WATER QUALITY IMPACT EVALUATION

Florida Department of Transportation
District Seven
US 41 (SR 45) Project Development and Environment (PD&E) Study
From Kracker Avenue to South of SR 676 (Causeway Boulevard)
Hillsborough County, Florida

Work Program Item Number: 430056-1
ETDM Number: 5180

**SOUTHWEST FLORIDA WATER MANAGEMENT DISTRICT
RESOURCE REGULATION DIVISION
PRE-APPLICATION MEETING NOTES**

Water Body ID (WBID) Map

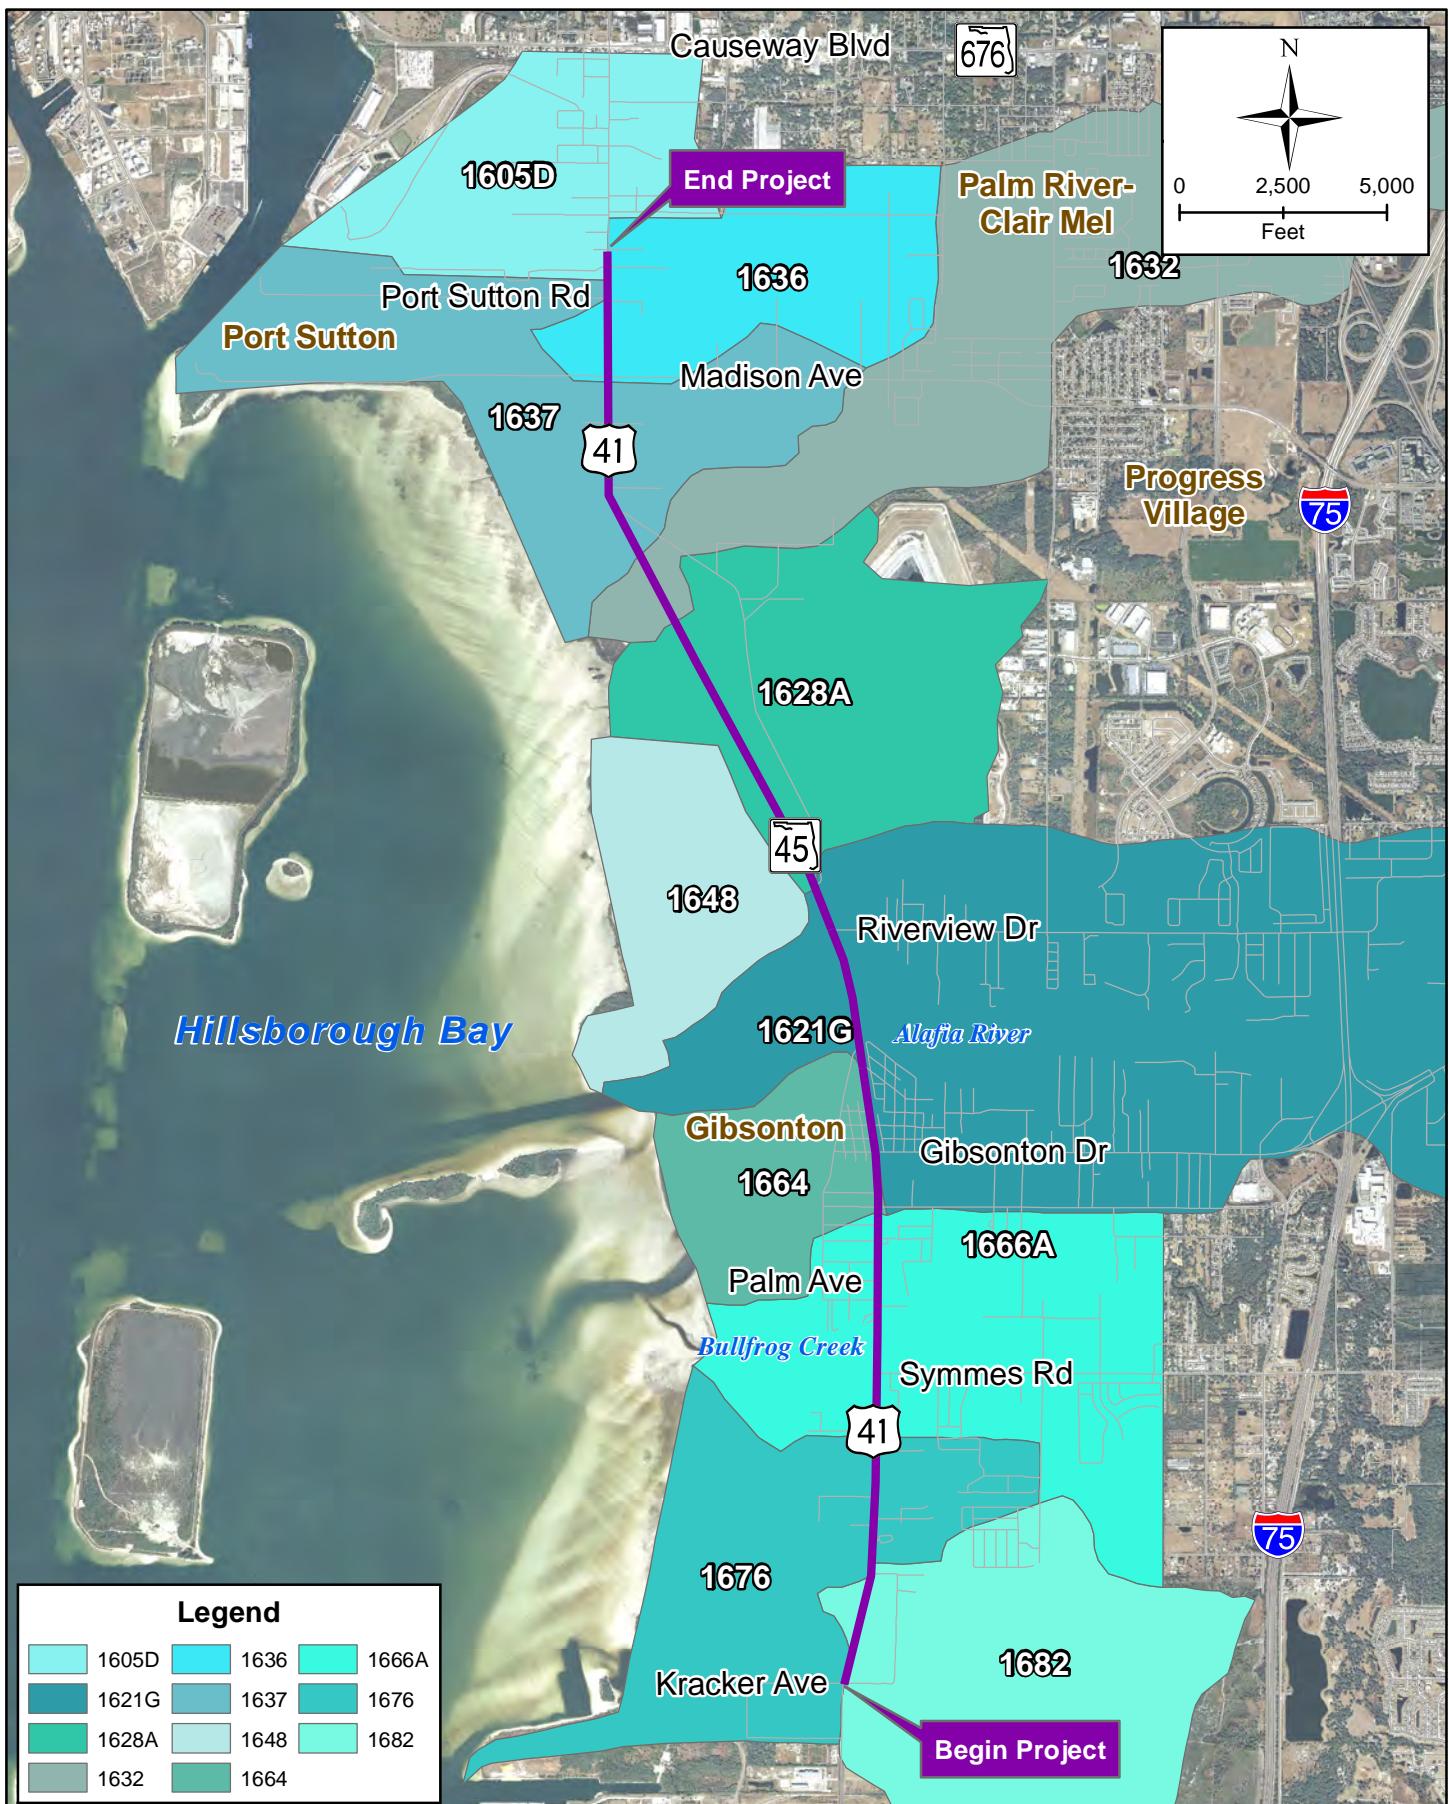
- WBIDs need to be independently verified by the consultant - Multiple waterbodies:
- WBID 1605D – Delaney Creek Tidal on the study list for dissolved oxygen.

- WBID 1636 – Port Sutton Ditch on the study list for dissolved oxygen.
- TB Estuary Reasonable Assurance Plan – requires improvement for nitrogen.
- WBID 1632 – Delaney Creek Popoff Canal on the study list for dissolved oxygen.

- WBID 1628A – Archie Creek (Tidal) on the study list for dissolved oxygen.
- WBID 1621G – Alafia River above Hillsborough Bay impaired for nutrients and dissolved oxygen.

- WBID 1666A – Bullfrog Creek on the study list for dissolved oxygen.
- WBID 1676A – Dug Creek on the study list for dissolved oxygen.
- WBID 1682 – Kitchen Branch on the study list for dissolved oxygen.
